RECOMMENDED SERVICE BULLETIN**NUMBER:** SB13-01**REVISION:** 00**DATE:** January 16, 2013**SUBJECT:** CARGO DOOR CATCH SWITCH ACTUATOR UPGRADE**EFFECTIVITY:**

TITLE: **Cargo Door Catch Switch Actuator Upgrade**
SERIAL RANGE: **As Required**
JASC CODE: **5270**

PAGE: **1 of 9**
REPORT NO.: **FSI-038**
REVISION: **02**

Figure 5-1: Illustration of Cargo Door Catch Assembly Before/After Modification

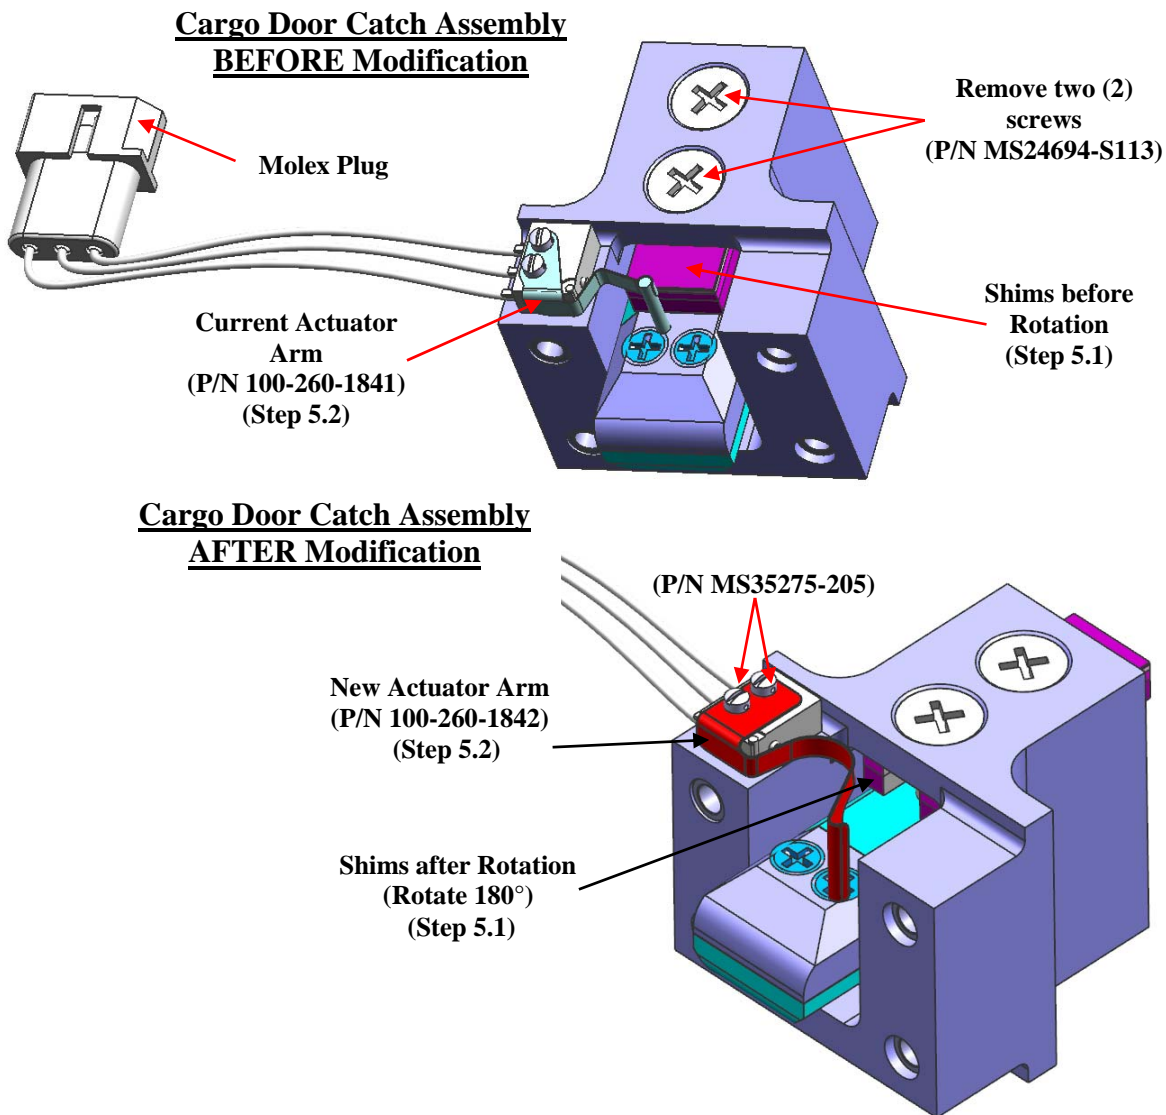
This Field Service Instruction provides guidance for installing the four (4) new catch switch actuators on the cargo door warning switches, as well as rotating the door catch shims to prevent interference with the new actuator arm.

1. Remove the two (2) screws (P/N MS24694-S113) holding the door catch assembly together.
2. Remove the shims located on the top side of the assembly.
3. Rotate the shims 180° and install as shown in **Figure 5-1**. This will allow clearance for the new actuator arm.
4. Reinstall the shims into the housing and reinsert the two screws (P/N MS24694-S113).

1. Remove the two (2) screws (P/N MS35275-205) attaching the switch actuator arm (P/N 100-260-1841) to the snap action switch (P/N 100-260-1840).
2. Replace the existing actuator arm (P/N 100-260-1841) with the new actuator arm (P/N 100-260-1842) and install the new screws (P/N MS35275-205). Refer to **Figure 5-1**.
3. Align actuator arm square with switch.

Figure 5-2: Molex Plug and Pin Location

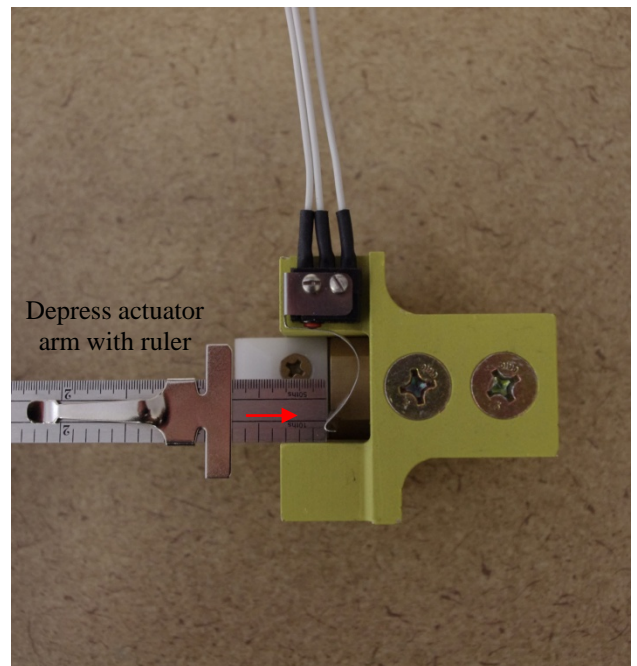
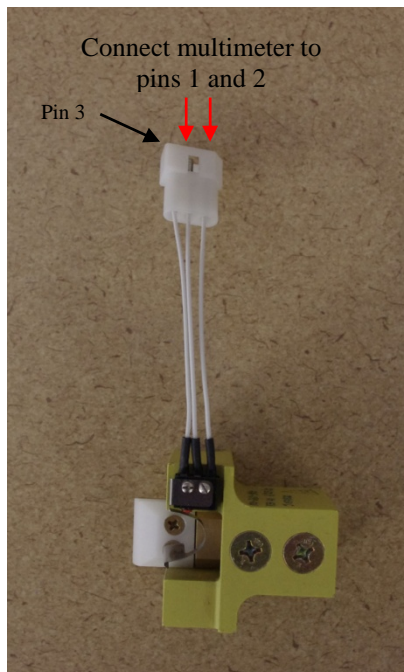
1. Connect multimeter to cargo door switch plug (Molex plug) pins 1 and 2 (**Figure 5-2**).
2. Using a ruler, depress actuator arm until multimeter reads a closed circuit (**Figure 5-3**).

3. Note the distance between the edge of the wear pad and the tip of the switch actuator arm.
 - a. If distance is less than .700 in., verify actuator arm screws are tight and proceed to step 4.
 - b. If distance is greater than or equal to .700 in., perform the following:
 - Loosen actuator arm screws.
 - Rotate the actuator arm slightly (**Figure 5-4**).
 - Perform a functional check.
 - Repeat as needed.
4. Verify clearance throughout full travel of actuator arm, ensuring that it does not catch on the wear pad or other components (**Figure 5-5**). Adjust actuator arm as needed.
